Subject: Byron Generating Station Units 1 and 2
Braidwood Generating Station Units 1 and 2
Fire Protection
NRC Docket Nos. 50-454/455 and 50-456/457

PROPOSED MODIFICATIONS TO LOWER CABLE

SPREADING ROOMS CO₂ SYSTEM

Figure 1

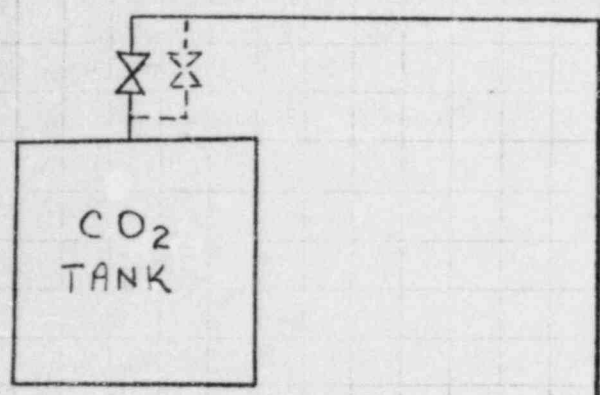
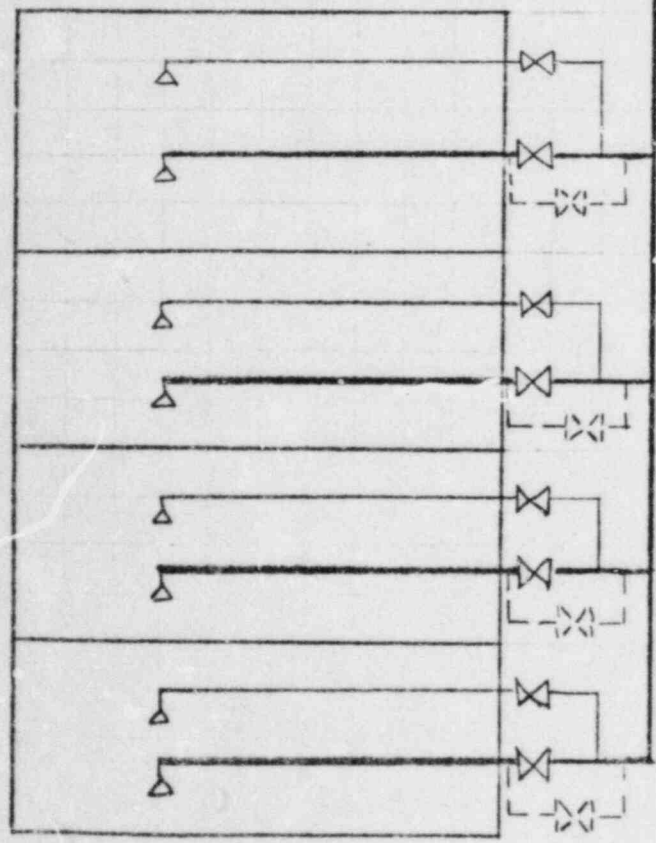
As presently designed, the Byron/Braidwood CO₂ suppression system consists of a single 10 ton storage tank, a single tank discharge valve and header, and individual zone discharge valves and piping for each hazard zone. For the lower cable spreading rooms each hazard zone has a large (1 1/2" to 4") initial discharge pipe with zone discharge valve and a smaller (3/4" to 1") extended discharge pipe with its own discharge valve. The zone discharge piping is sized on the basis of room size. This is shown diagrammatically on the attached Figure 1, in which the existing system is shown in solid lines.

The active components in the system are the tank and zone discharge valves. We propose to provide redundant tank and zone discharge valves as represented on Figure 1 by the dashed lines. The new valves and associated equipment will be U.L. listed. The modifications will be implemented in accordance with NFPA 12. A redundant zone discharge valve is provided for the initial discharge line only. Redundant extended discharge valves are not required because the capacity of the storage tank is such that multiple shot capacity is provided for even the largest hazard zones, providing adequate redundancy for the zone discharge valves.

The new tank discharge valve will have two modes of operation: 1) it will have manual pushbuttons located near each lower cable spreading room which it protects which will electrically operate its EMPC; and 2) it can be manually actuated by a lever on the EMPC. The new zone discharge valves will only be operable by a manual lever on the EMPC, since they will be located near the hazard zones which they protect. These new valves are expected to be used only in the event of failure of the normal tank or zone discharge valves. The Pre-Fire Plan strategies will be modified to include the use of this additional backup capability if required.
